STATEMENT OF PASSING OVER INFORMATION

CODE COMPLIANCE CERTIFICATE

Proposed Conservatory for
Mr R. D. Patterson
22 Pinewood Grove
Paraparaumu.

Re: Conservatory - 22 Pinewood Grove.

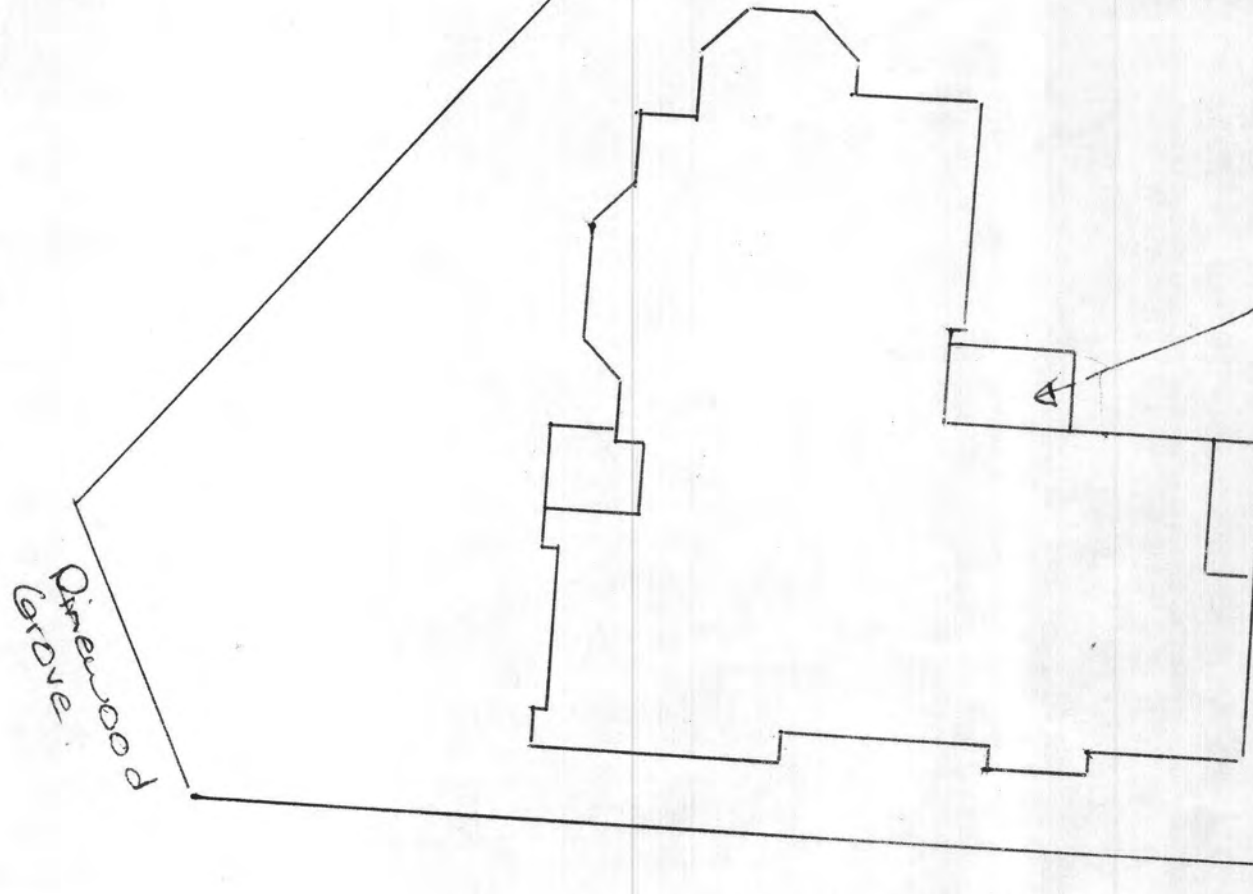
1. No DWP Stickers provided with Aluminium Joinery indicating Rating of windows. Provide to Council in writing DWP Rating of Conservatory, and Conservatory complies with Very High Wind Rating + NZS 4223: Part 3, 1993.
2. Provide Stickers to Aluminium Conservatory on site.

This letter is to confirm that the conservatory for Mr Patterson at 22 Pinewood Grove was built to a wind-loading of 1,550 p.a.

Plan View

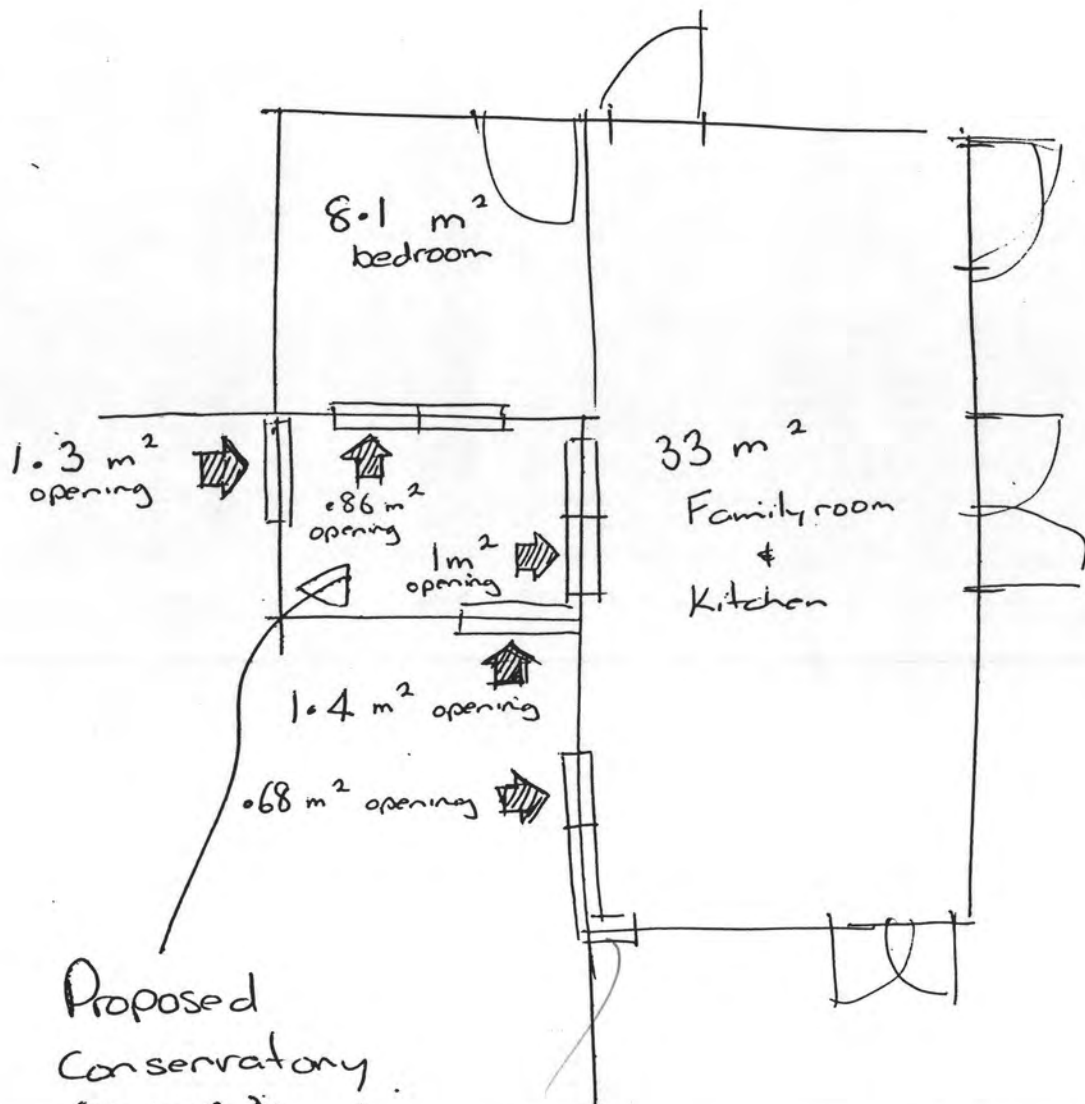
Recently I telephoned you regarding a situation where we have applied for a building consent for a conservatory which covers a bedroom window and a family room window. (See enclosed drawing).

My revised proposal to the K.C.D.C. was to provide extra enlarged opening windows adjacent to the windows in the bedroom and family room (see plan view). The K.C.D.C. has turned this proposal down, stating that borrowed ventilation conflicts with the Building Regulation requirement for ventilation to the exterior. (See K.C.D.C. letter of 3/7/95). They have also referred me to a B.R.A.N.Z. report on conservatories (also enclosed).

From the K.C.D.C. comments I take it that "borrowed" ventilation would not be satisfactory under any circumstance. Is this correct in your opinion?

My customer does not wish to provide extractor fans (if this can be avoided). While an extra opening window can be provided to the kitchen (where one already exists), it is not possible to provide another window to the bedroom, opening directly to the outside.

We have discussed your proposal again but feel that the additional sashes within the conservatory can only provide borrowed ventilation which conflicts with the Building Regulation requirements for ventilation to the exterior.

Concessions are able to be made when considering lighting needs only.
